DESIGN ADVISORY BOARD

DESIGN ADVISORY BOARD Tuesday November 9, 2021 3:00 PM

To: The Design Advisory Board
From: Mary O'Neil, AICP, Principal Planner
RE: ZP21-509 72-76 Elmwood Avenue
Date: September 28, 2021

To: The Design Advisory Board
From: Ryan Morrison, Associate Planner
RE: ZP-21-732, 278 Main Street
Date: November 9, 2021

SITE PLANS

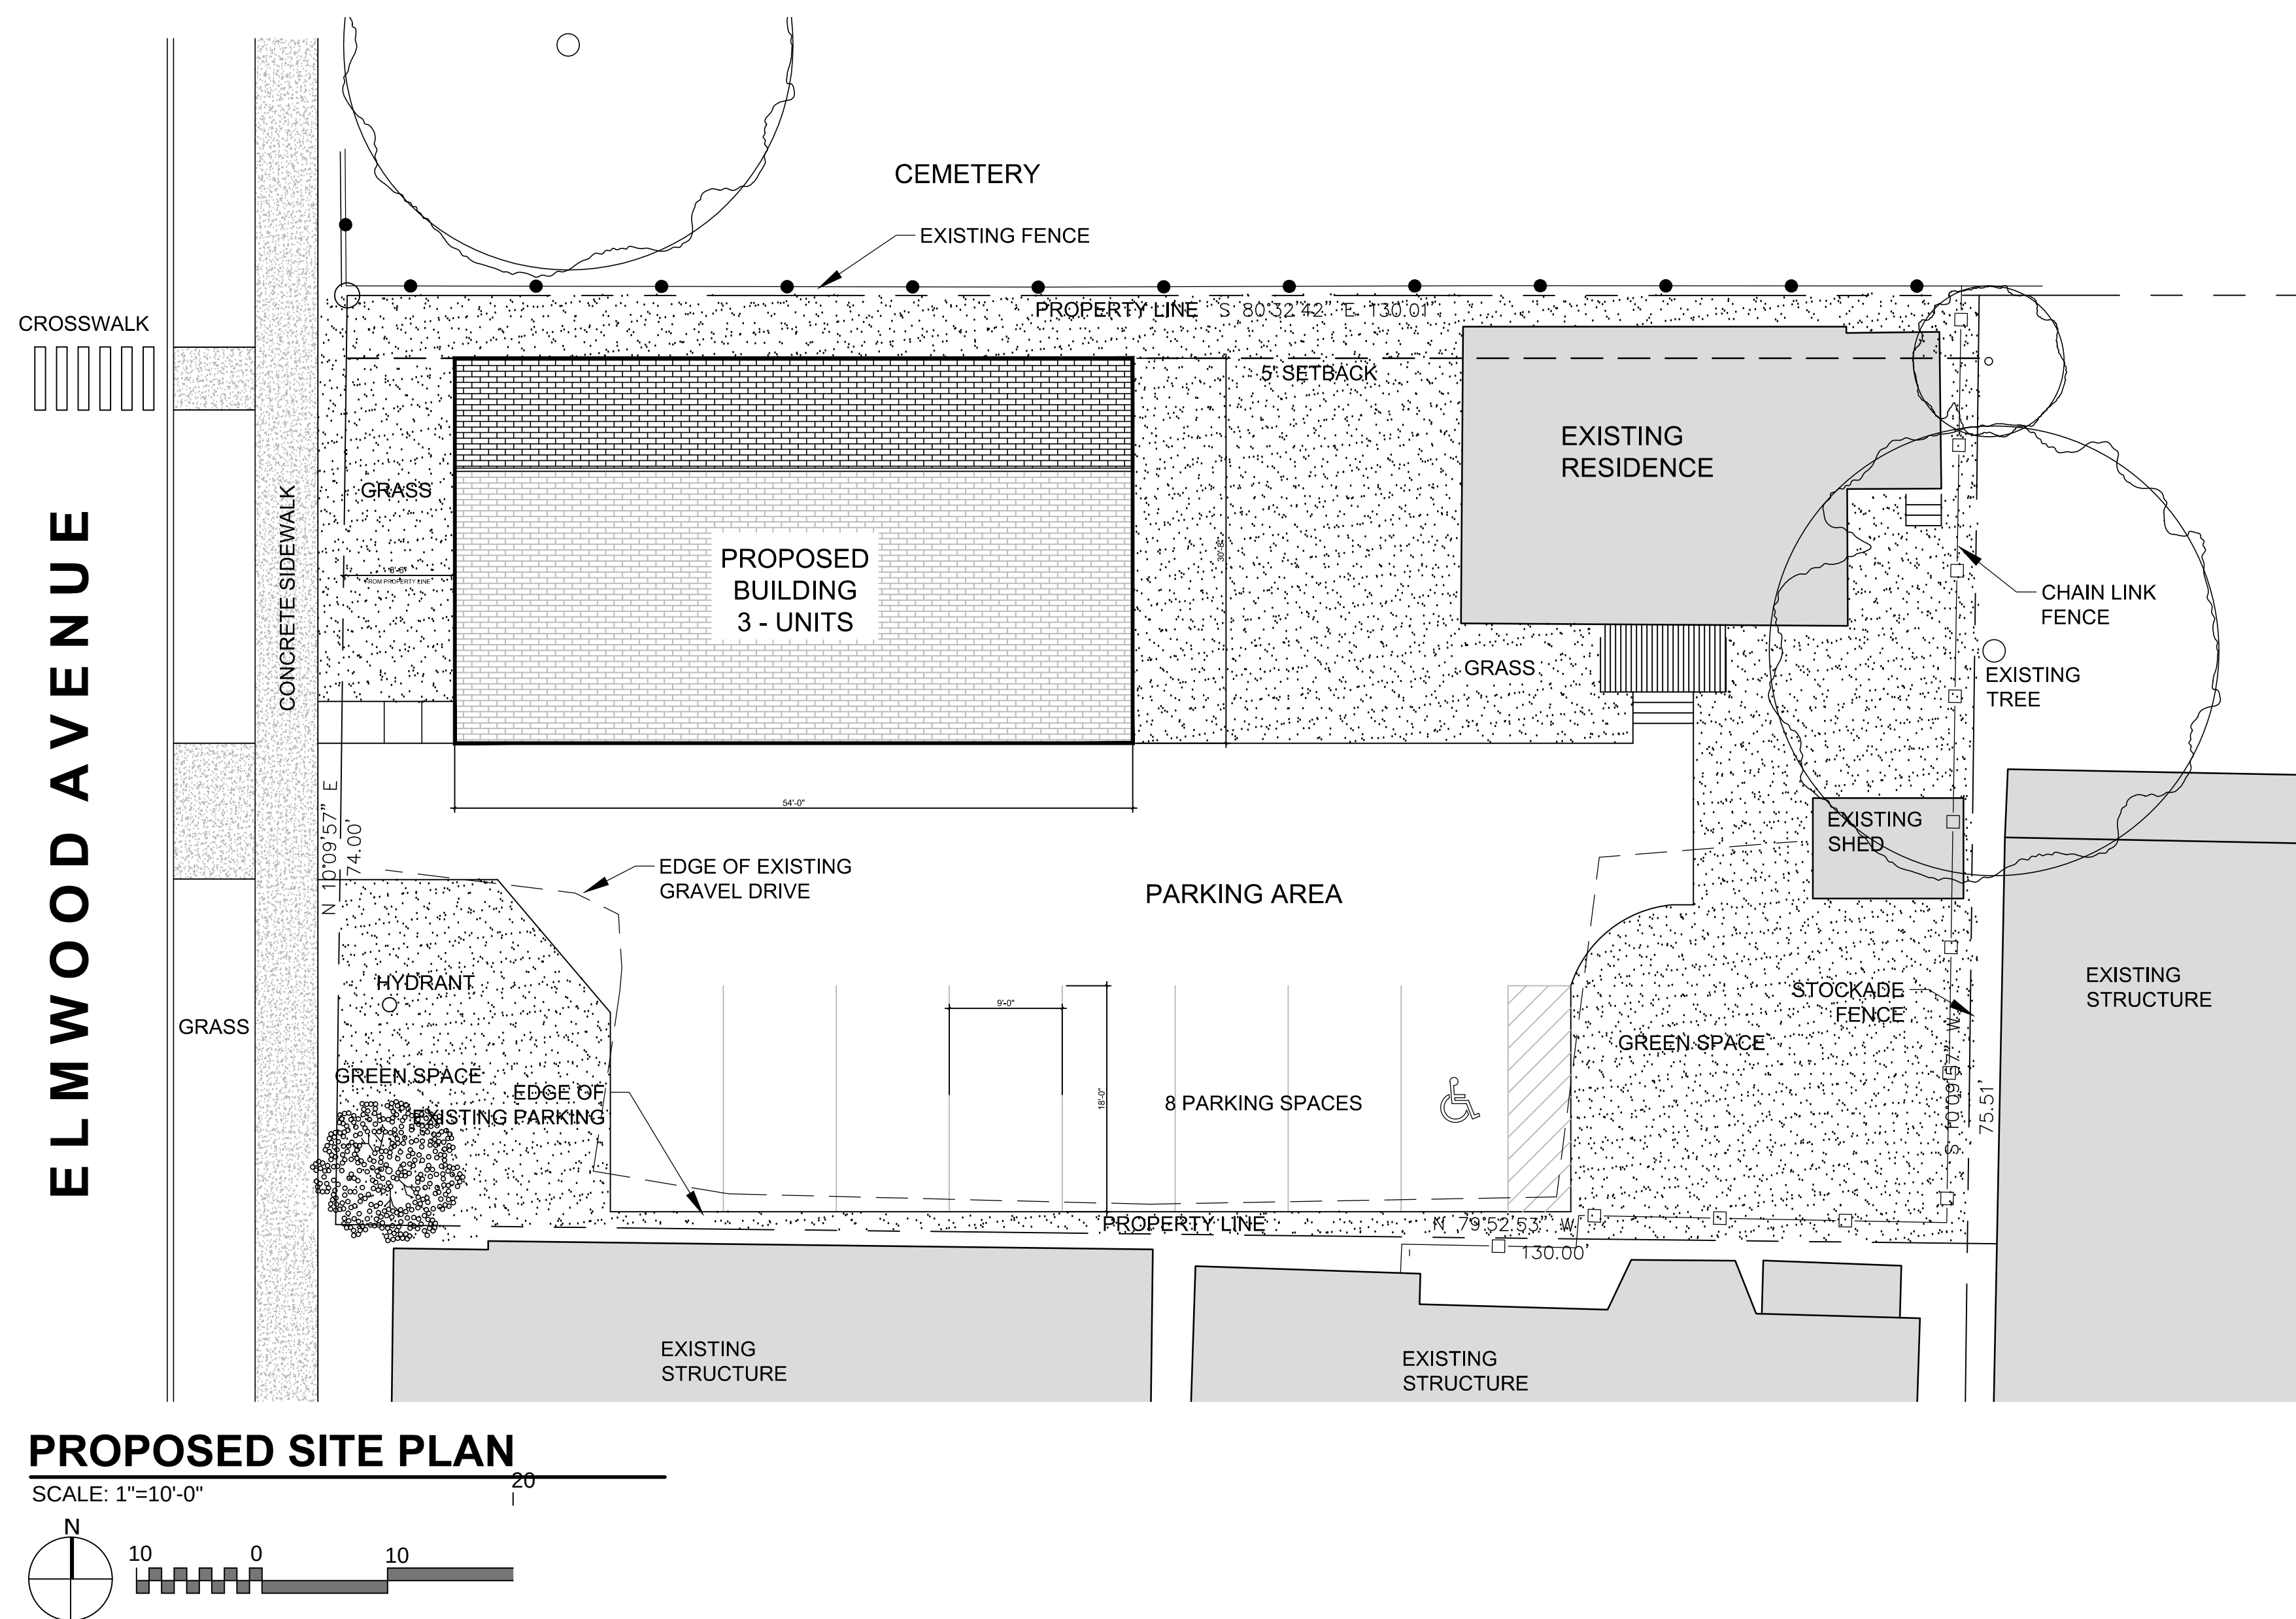
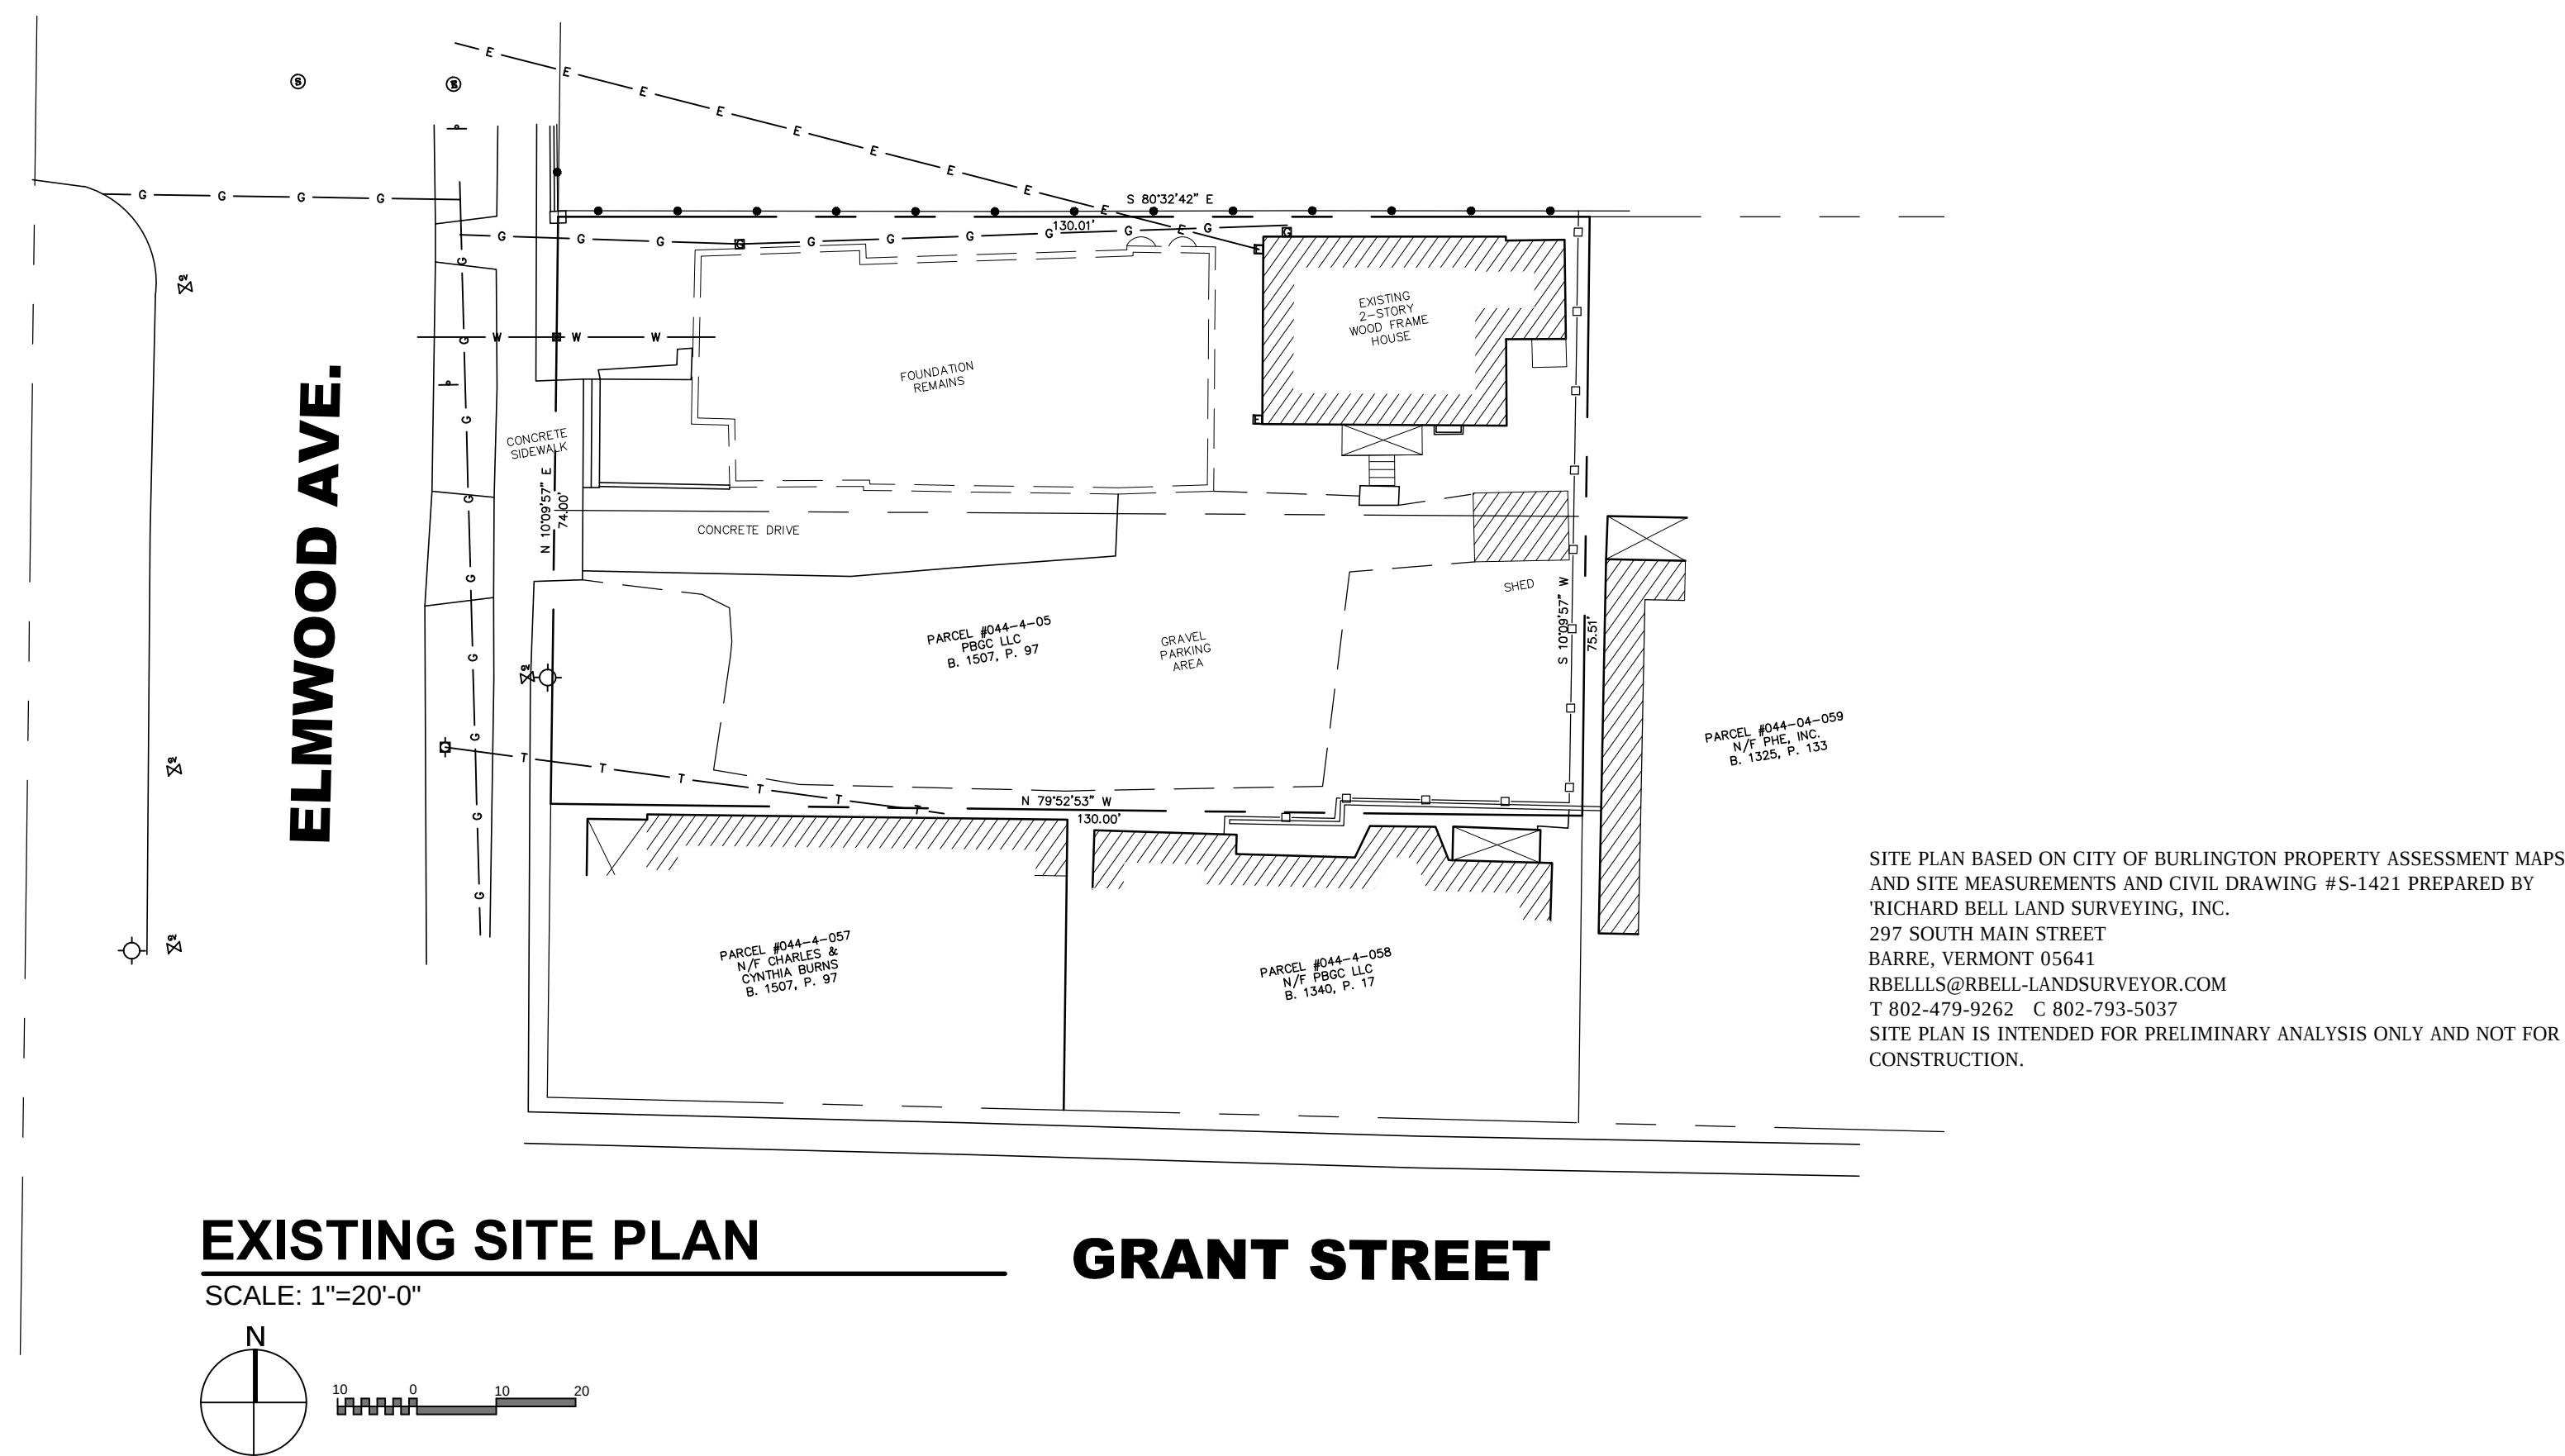
There is no elevator included in the plan. A single handicap parking space with an access aisle is illustrated. This space is located furthest from entrances to the new building; however if intended for the existing single family home is appropriately sited. Conformance to ADA standards is under the jurisdiction of the building inspector.

The site plan illustrates 8 on site parking spaces, meeting the minimum parking requirement for the Neighborhood Parking District. There is sufficient room for cars to back out and re-enter Elmwood Avenue from the parking area.

Existing trees and fencing are shown on the site plan. No landscaping plan has been provided. Some plantings are encouraged to “settle” the new building into the site, and to screen the parking area from the street.

The site plan does not reveal any mechanical equipment. If condensing units, mini-splits, or other external mechanical equipment is intended, they must be illustrated on the site plan/building elevations as appropriate, and screened where required.

The applicant needs to disclose the location of trash/recycling facilities. If a dumpster is proposed, it must be identified on the site plan, meeting required setbacks and be enclosed on all four sides to prevent blowing trash.

- Any intended mechanical equipment (HVAC, Condensing Units, mini-splits, etc) shall be illustrated on the site plan/building elevations as appropriate. No mechanical equipment shall be allowed on the primary (westerly) elevation. Screening may be required elsewhere.

- Building elevations and the site plan must identify meters, utility connections, and mailboxes.
- A landscaping plan shall be provided, particularly with the addition of planting to screen the parking area from the public right-of-way.

- Bike parking shall be provided. In the Neighborhood Parking District, 1 long term bicycle parking space shall be provided for every 2 bedrooms. For the new three unit building, 6 long term bike parking spaces are required. These shall be shown on the plan, or identified as to location.
